Ref.:   AN 13/2.5-15/45   11 June 2015

Subject: Proposals for the amendment of the PANS-ATM (Doc 4444) relating to performance-based longitudinal and lateral separation minima and automatic dependent surveillance — contract (ADS-C) climb and descend procedure (CDP)

PROPOSED AMENDMENT TO THE PANS-ATM

**Figure 5-29. Calculation of longitudinal distance/time between aircraft —

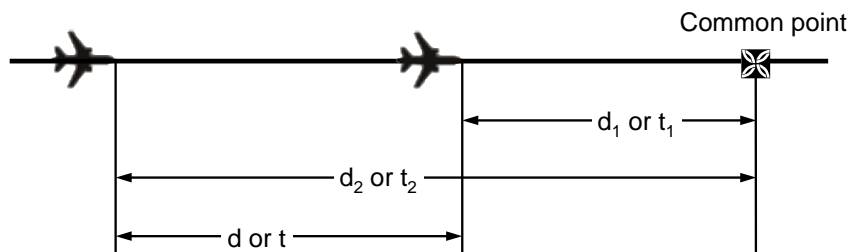
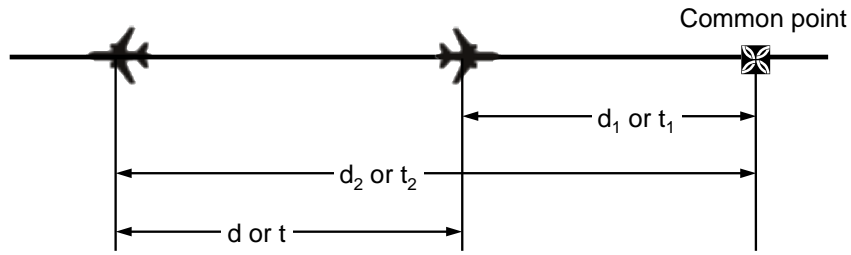
a)   when the aircraft are on the same identical track, the distance or time may be measured between the calculated positions of the aircraft or may be calculated by measuring the distances or times to a common point on the track (see Figures 5-29 and 5-30);

**Figure 5-32. Calculation of longitudinal distance/time between aircraft —
same track projected, but not identical (see 5.4.2.9.5 b))**

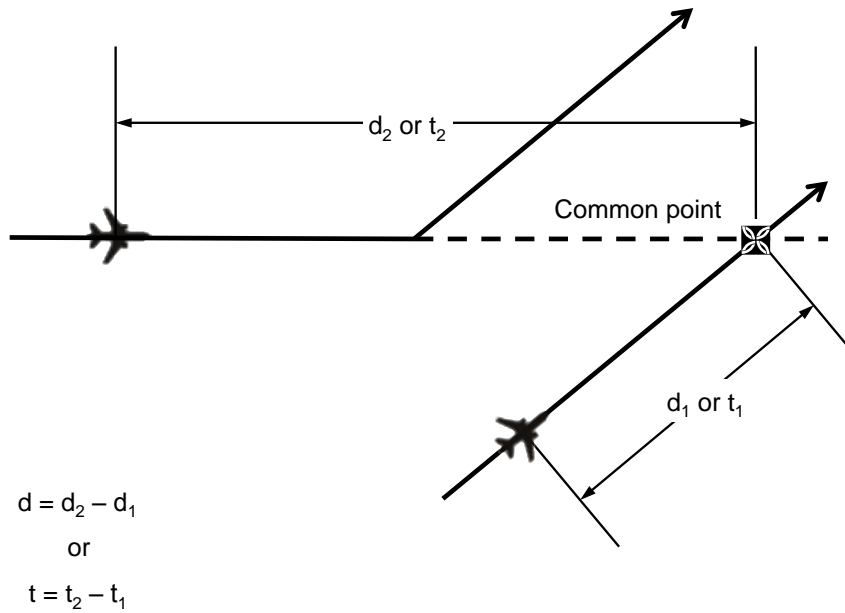
b)   when the aircraft are on same or reciprocal non-parallel tracks other than in a) above, or on crossing tracks, the distance or time shall be calculated by measuring the distances or times to the common point of intersection of the tracks or projected track (see Figures 5-31 to 5-33); and

**Figure 5-33. Calculation of longitudinal distance/time between aircraft —
opposite sides of the common point (see 5.4.2.9.5 b))**

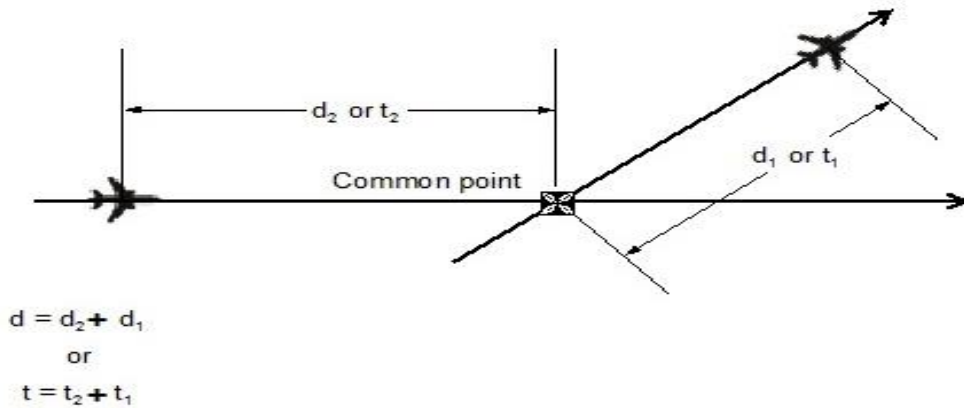
Note.— In all cases presented in Figures 5-29 to 5-34, "d" and "t" are calculated by subtracting the distance or time of the closer aircraft from the common point from the distance or time of the more distant aircraft from the common point, except in Figure 5-33 where the two distances or times are added and the order of the aircraft is not important in the calculation.

**Figure 5-34. Calculation of longitudinal distance/time between aircraft –
parallel tracks (see 5.4.2.9.5 c))**

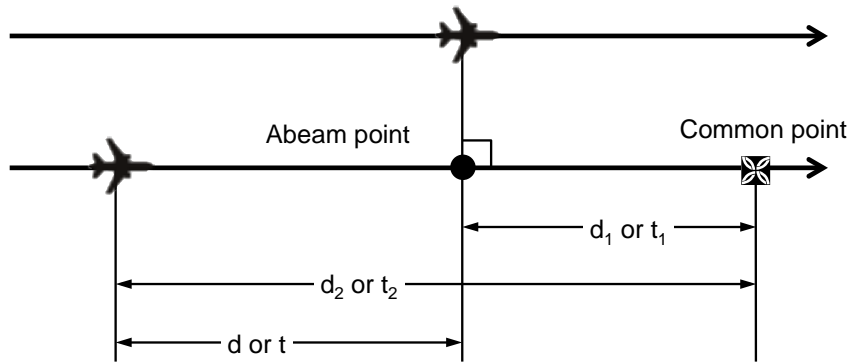
c)   when the aircraft are on parallel tracks whose protection areas overlap, the distance or time shall be measured along the track of one of the aircraft as in a) above using its calculated position and the point abeam the calculated position of the other aircraft (see Figure 5-34).
